Ikes at Cambria
8001 28th Avenue South
PL201900209

SHEET NO:
T
TITLE SHEET

SHEET NO:
A1.2
ENLARGED SITE PLAN

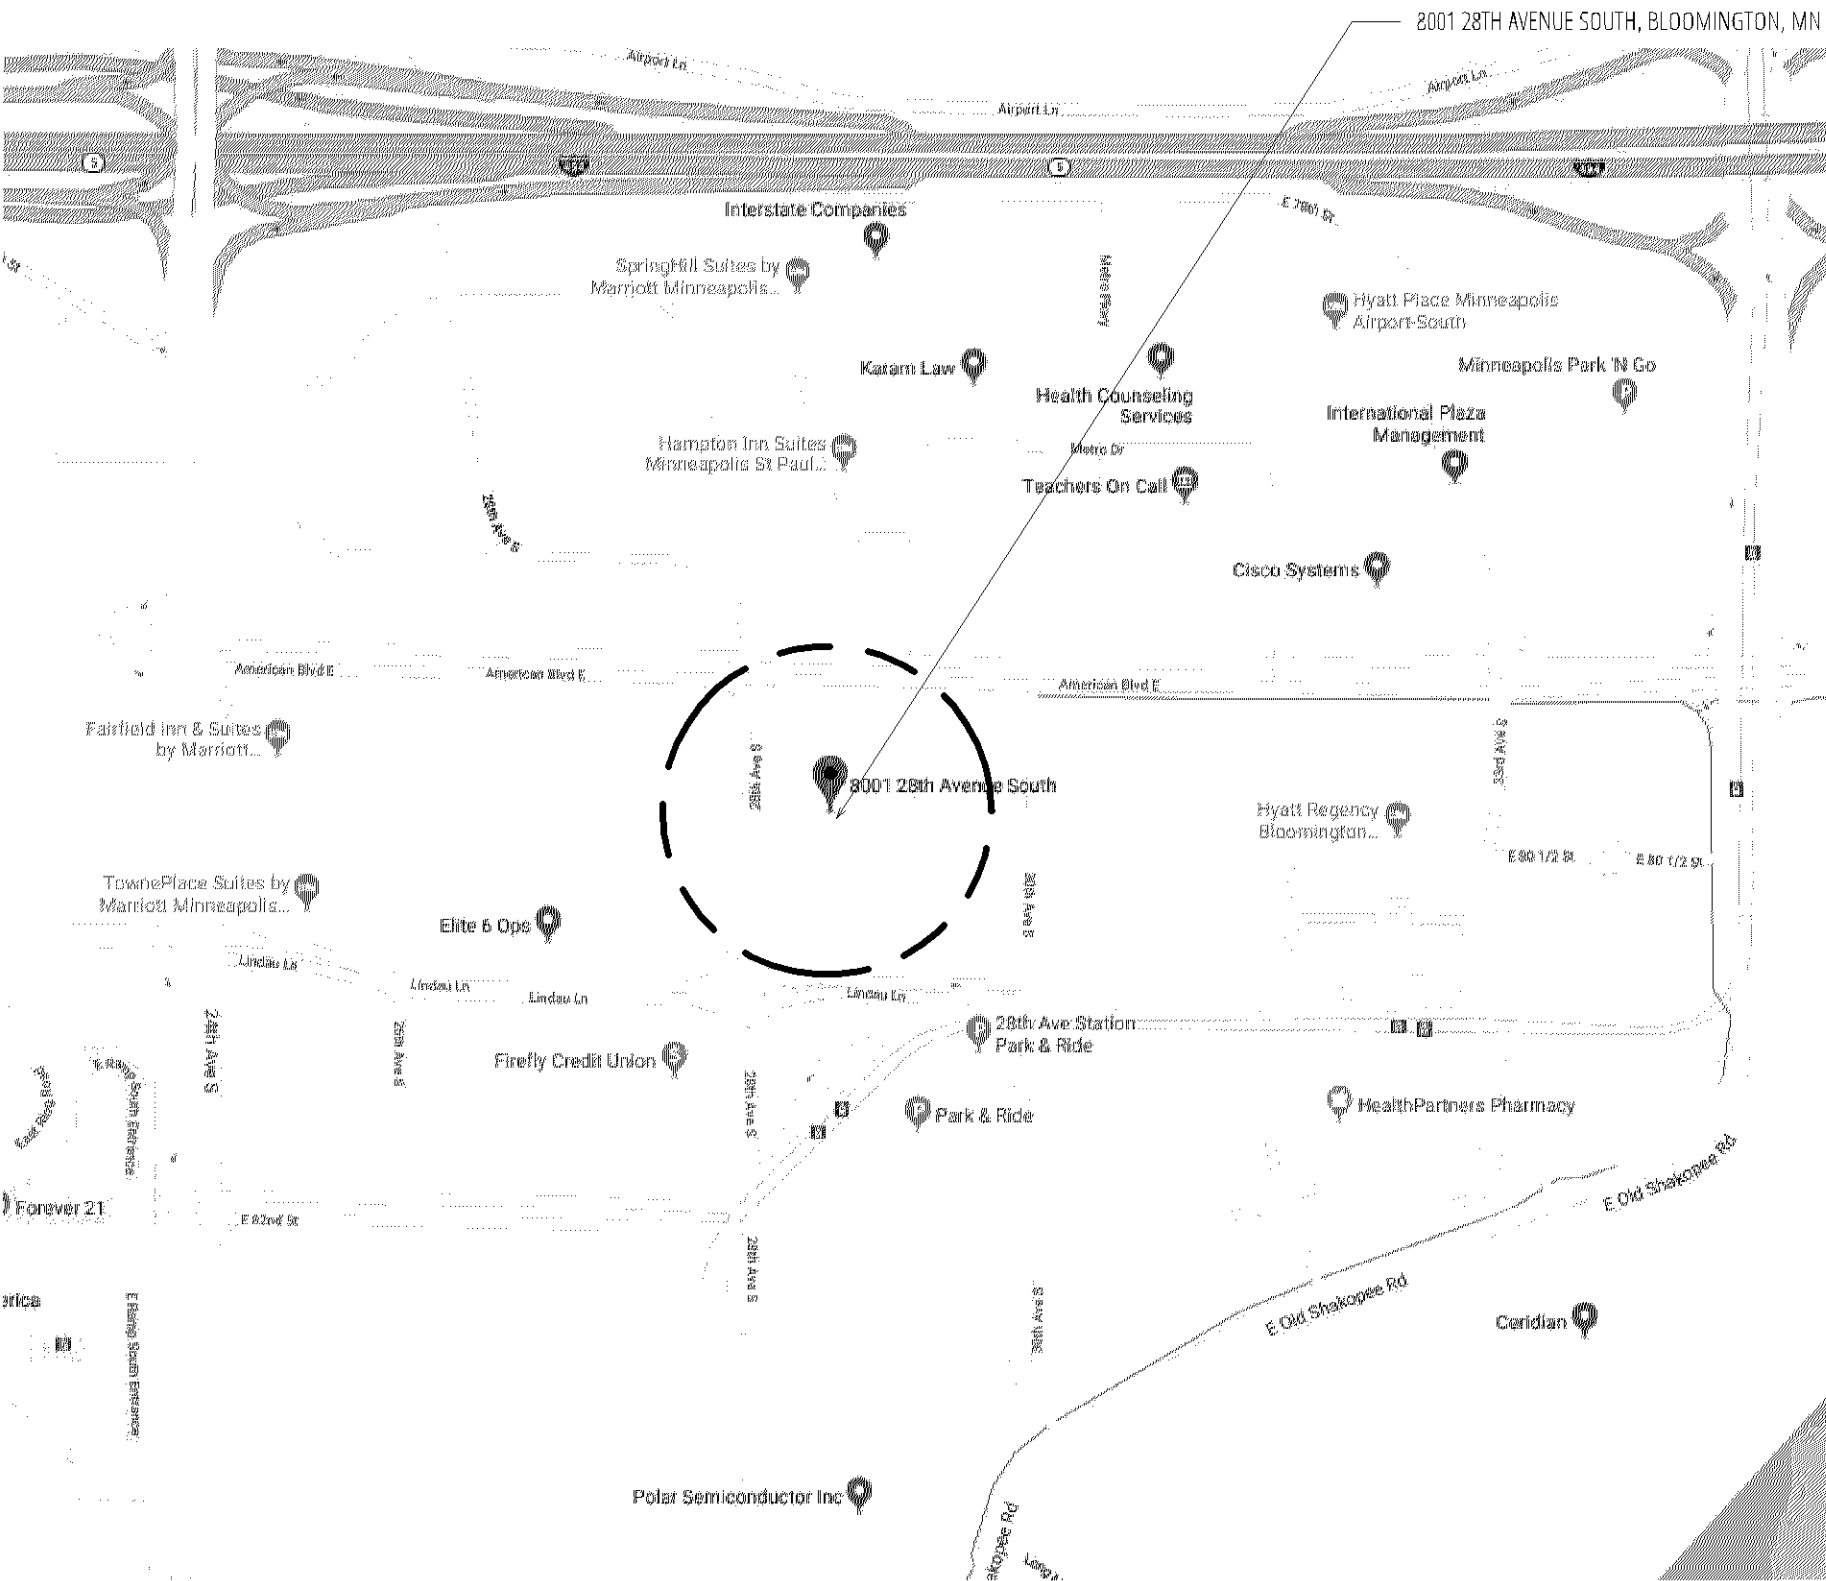
Provide building elevations that identify proposed exterior building materials. EIFS is not a permitted primary material. A minimum 50 percent transparency between 2 and 10 feet is required along 28th Avenue S. and and 25 percent along American Blvd. Include transparency percentages on building elevation drawings.

Provide an overall FAR calculation for the entire development. The minimum FAR in the LX district is 0.7. When the hotel development was approved, the City Council approved a small FAR deviation to go below 0.7. A further reduction approval may be necessary.

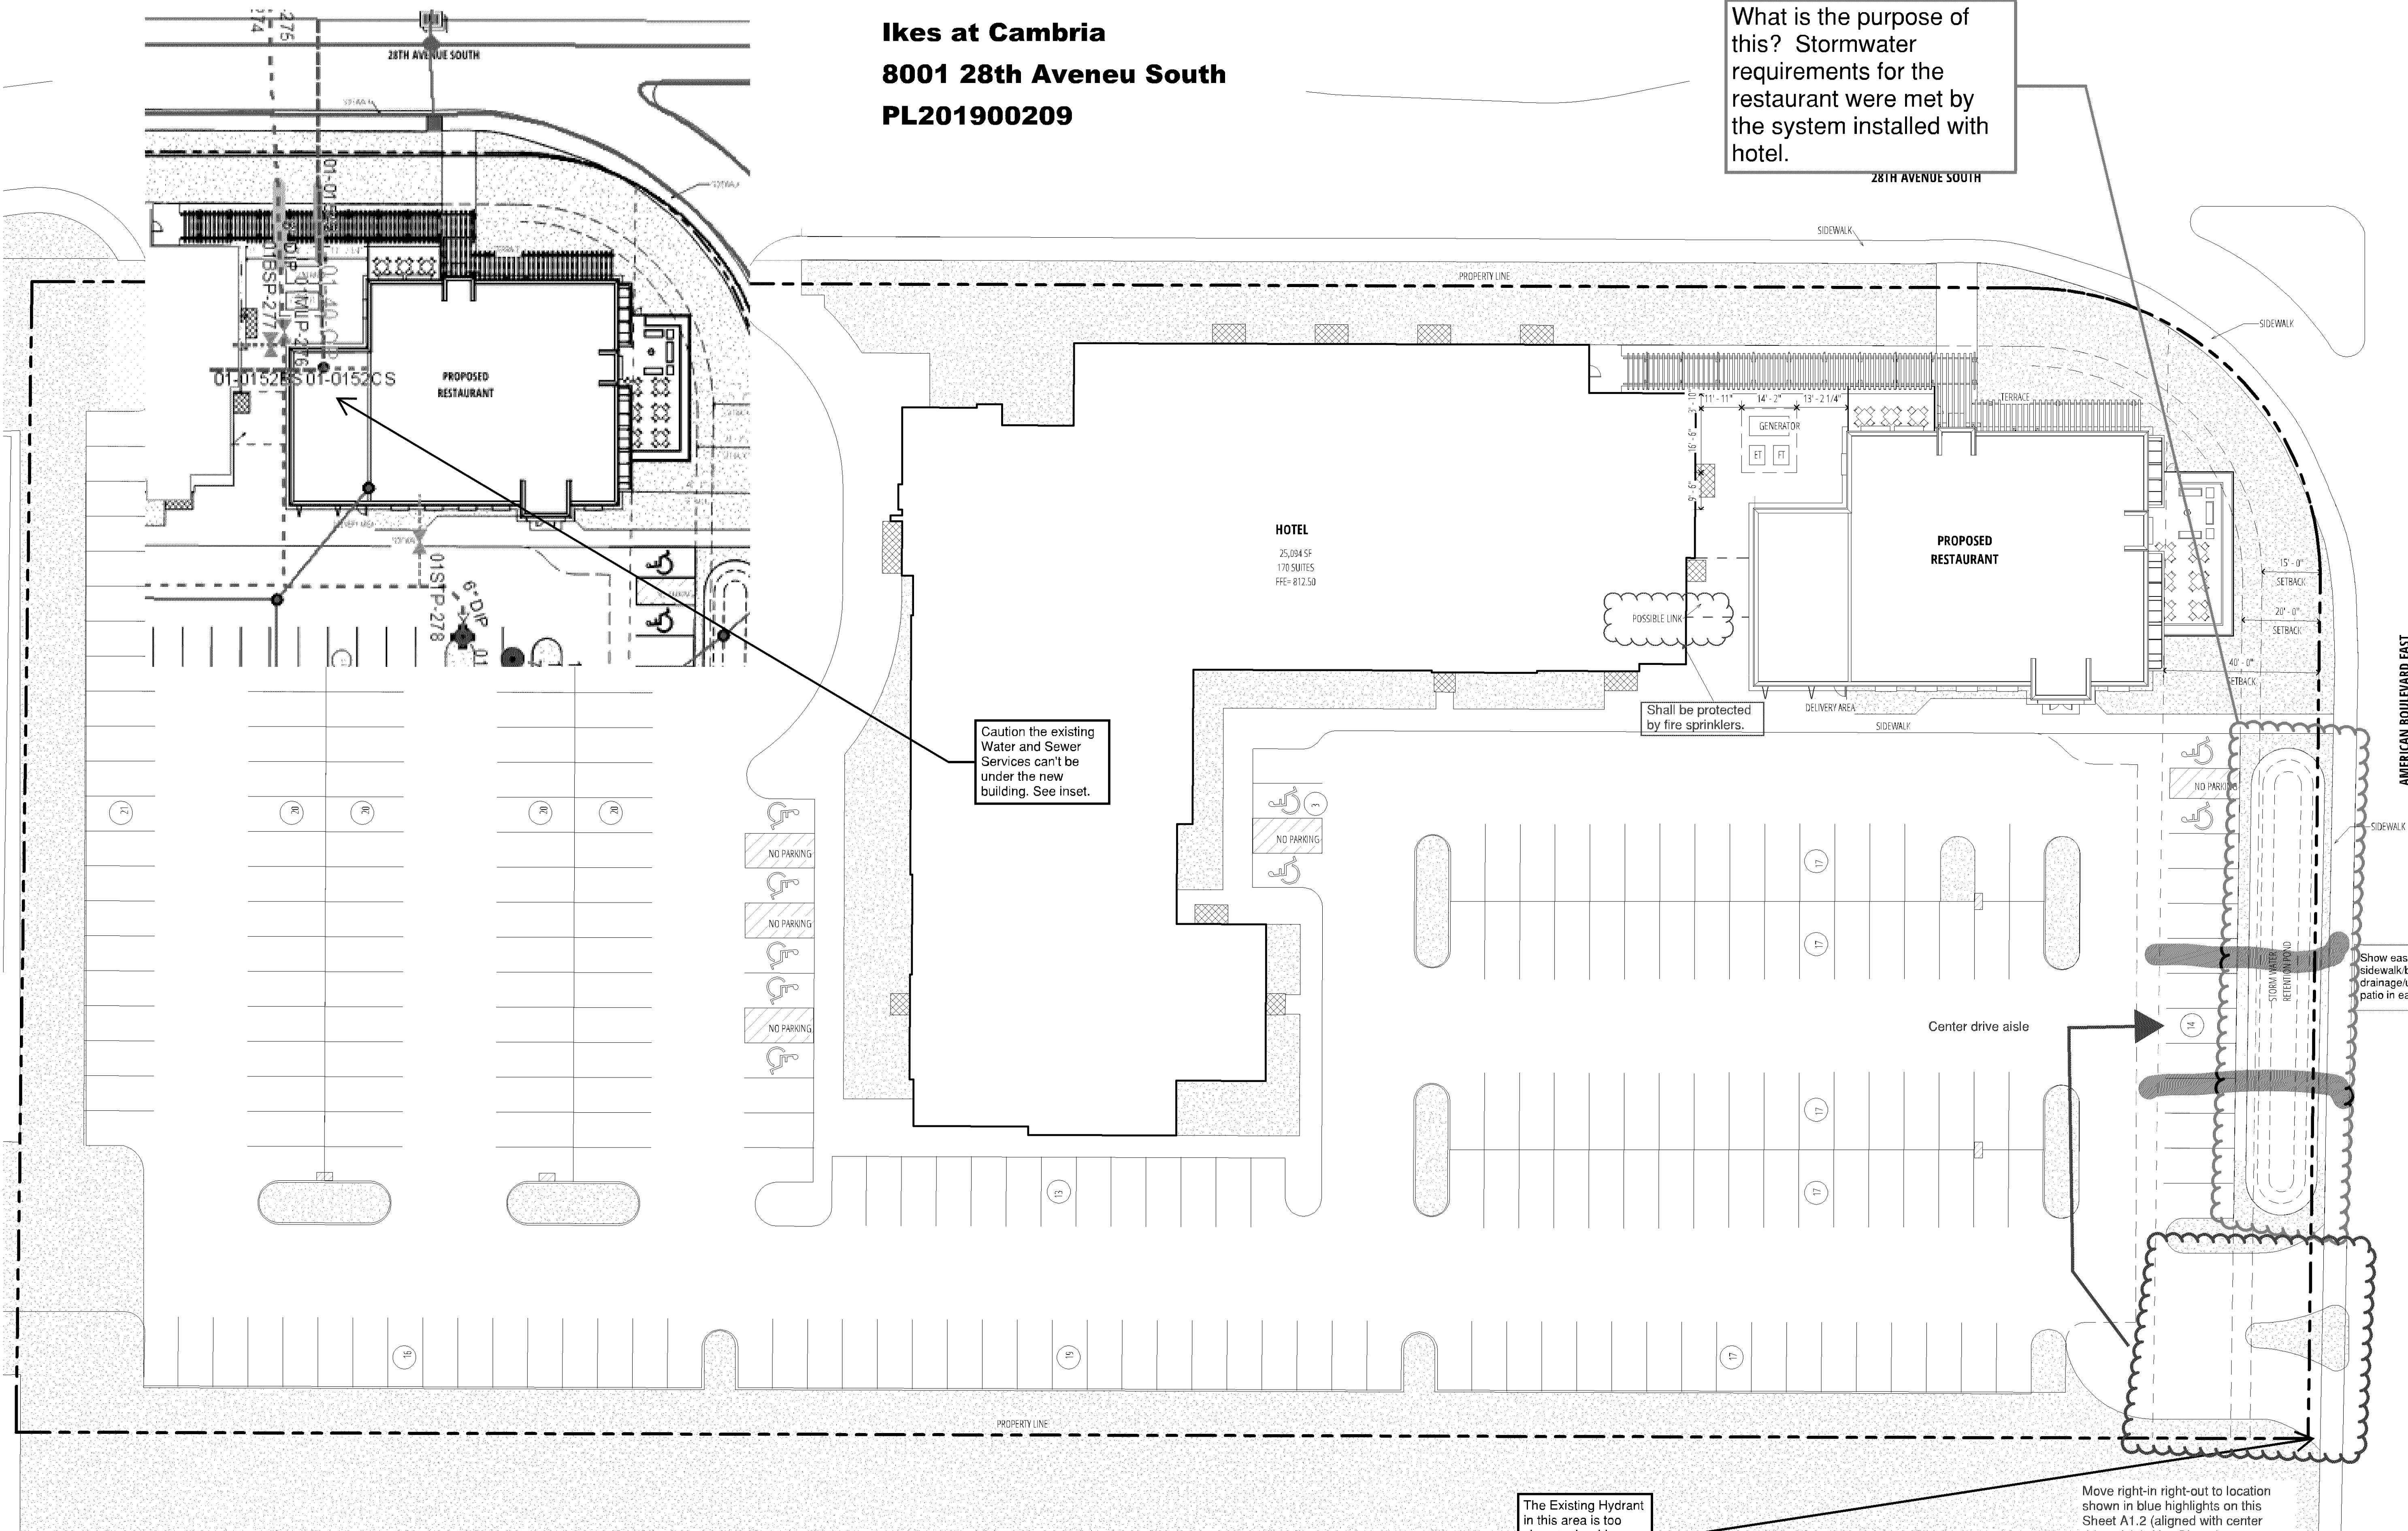
The Cambria Suites preliminary development plan included fully enclosed corridor between the hotel and restaurant. Consider retaining the shared corridor for the proposed restaurant.

Hydrant coverage shall be provided within 50' of the FDC and within 150' of all portions of the structure.

Fire Department Connection Shall Be front (main entrance) side of building.

insure the proposed landscaping doesn't interfere with access to the building.

Show easements: sidewalk/bikeway and drainage/utility. No pond or patio in easement area.

Correct demolished parking island line work.

13 stalls are depicted along American Blvd. The plan label is 14.

Proposed location of right-in right-out driveway aligns ingress and egress traffic nearly head on, depicts radius extending onto adjacent parcel, and also does not position egress traffic well for accessing the eastbound left turn bay to facilitate an EB to WB u-turn movement (pink highlight).

Radius on adjacent parcel.

What is the purpose of this? Stormwater requirements for the restaurant were met by the system installed with hotel.

Caution the existing Water and Sewer Services can't be under the new building. See inset.

Shall be protected by fire sprinklers.

The Existing Hydrant in this area is too close to the driveway and may be easily damaged.

Move right-in right-out to location shown in blue highlights which will facilitate access into the start of the EB left turn bay. Use Bloomington standard commercial driveway

Move right-in right-out to location shown in blue highlights on this Sheet A1.2 (aligned with center drive aisle). Use Bloomington standard commercial driveway detail, no splitter island.

4
A1.3 CONCRETE CURB DETAIL
SCALE: 1 1/2" = 1'-0"

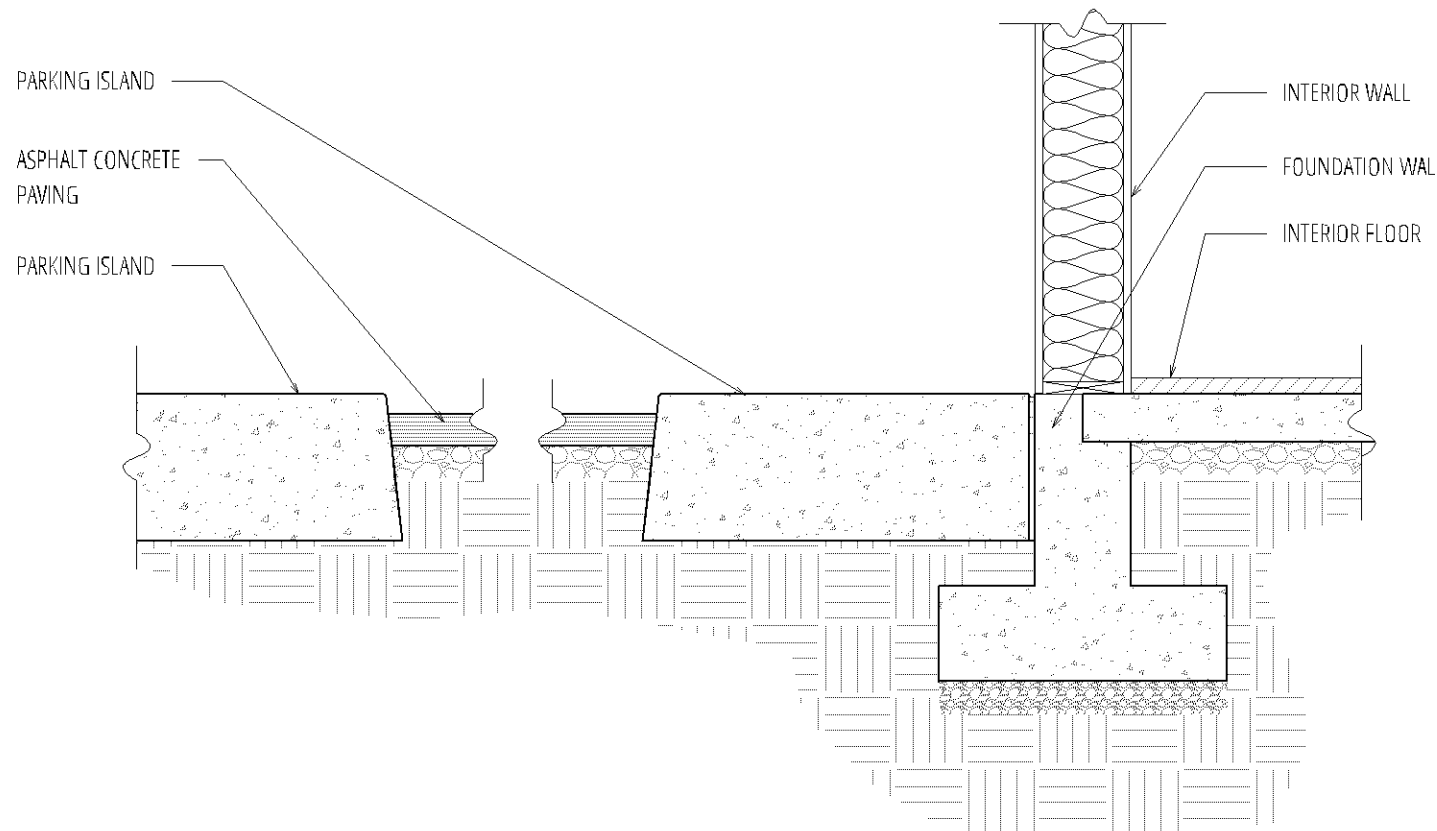
Depth is not show for curb detail

2
A1.3 RETAINING WALL DETAIL
SCALE: 1/2" = 1'-0"

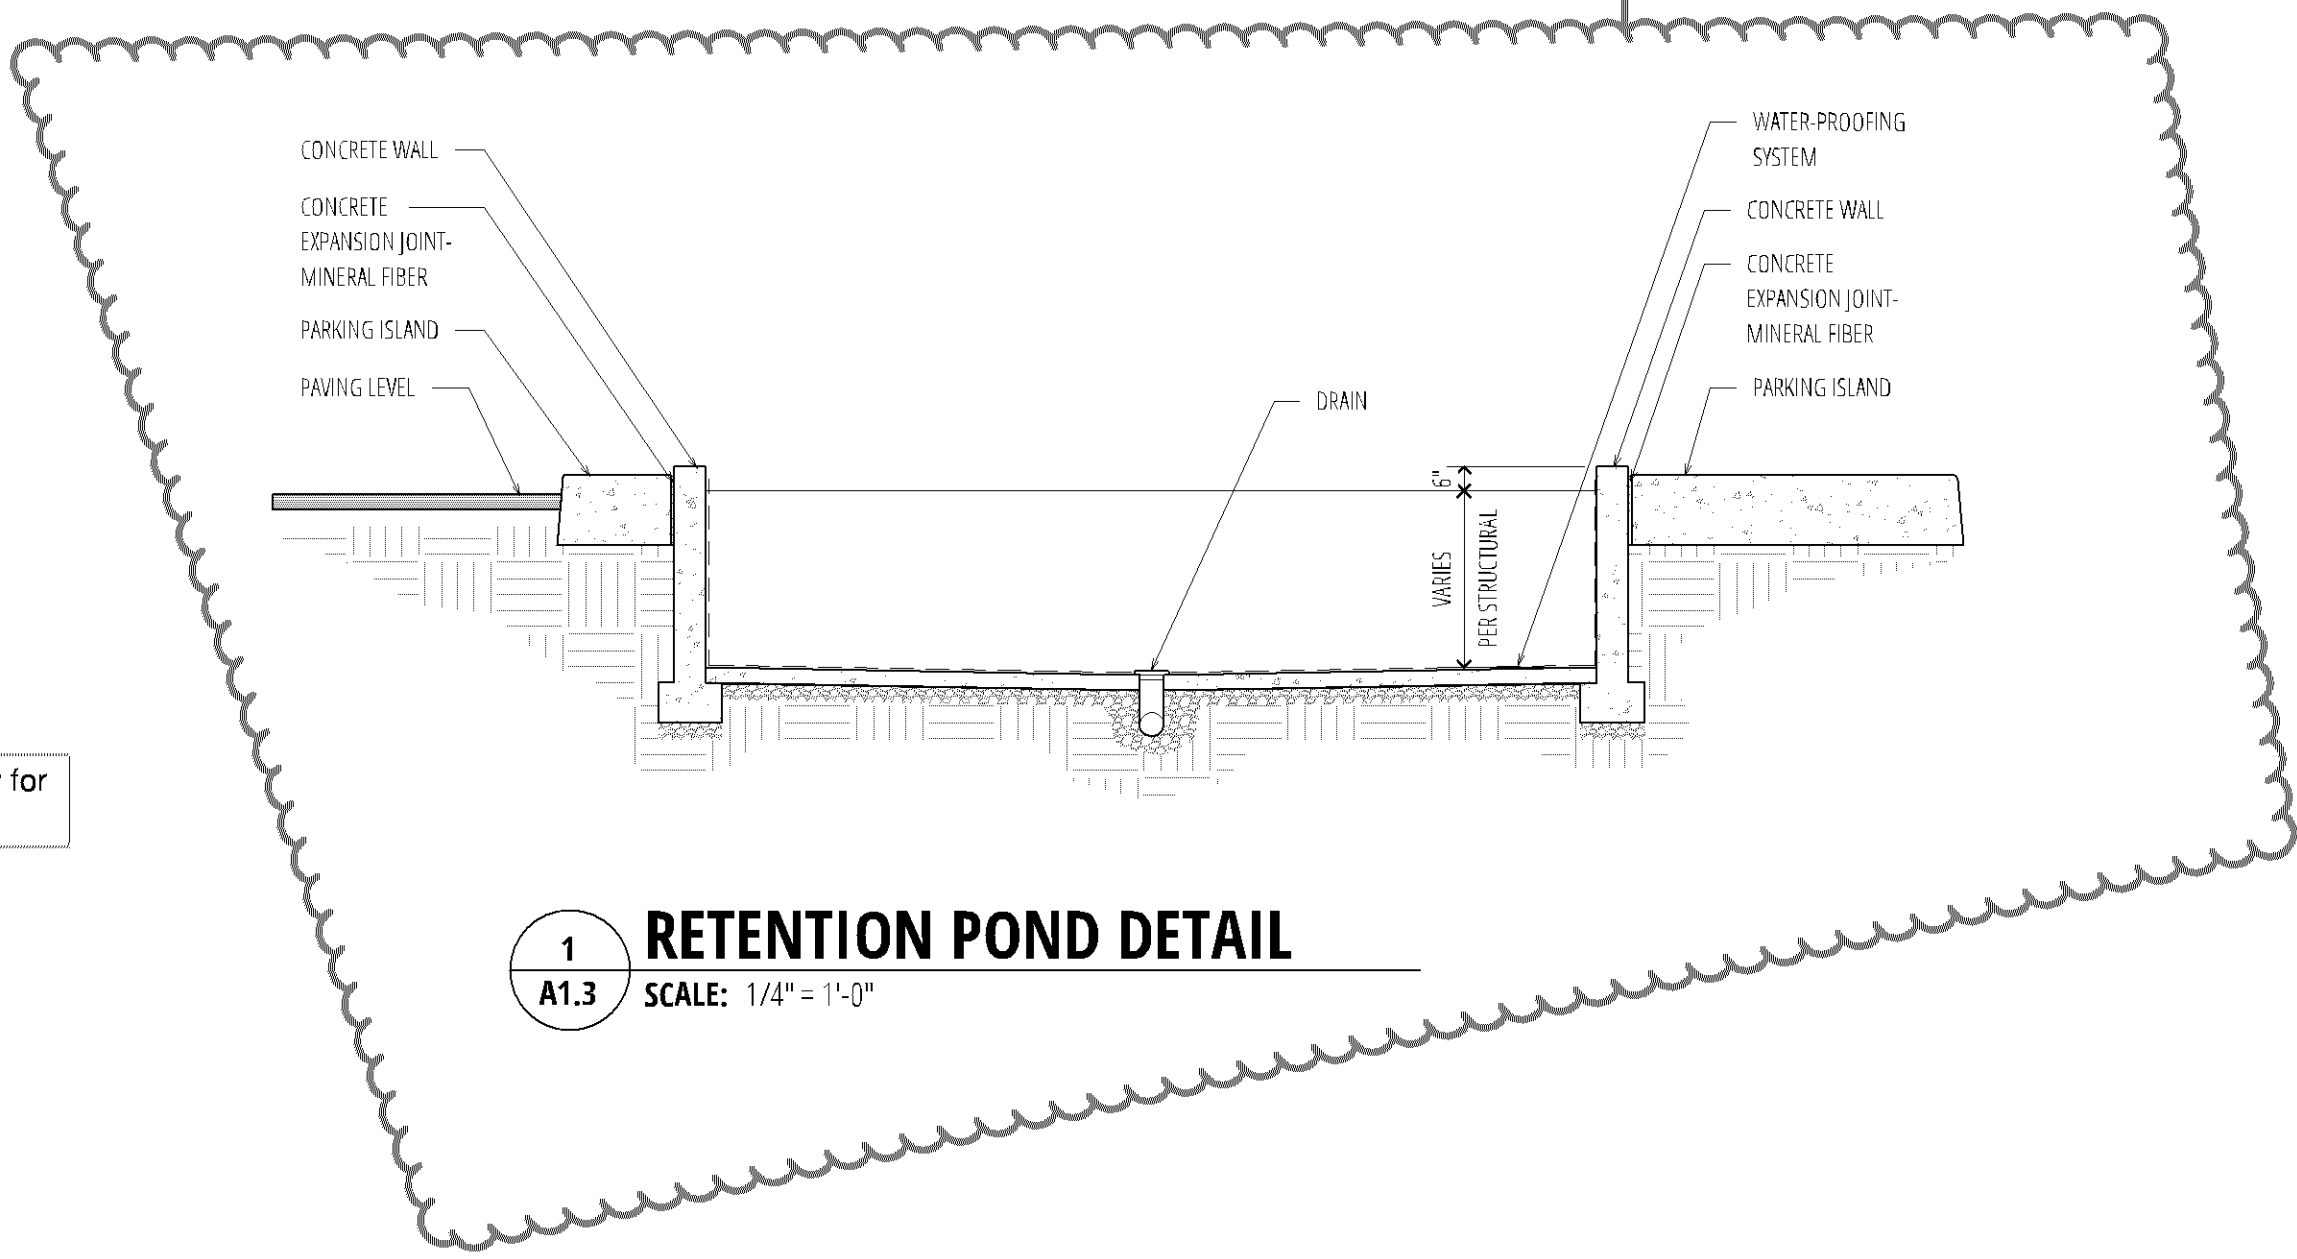
Retaining wall not shown on site plan. Is this for the stormwater pond? If so it needs to show proposed slopes and accurate adjacent materials

This detail does not match grading plan.
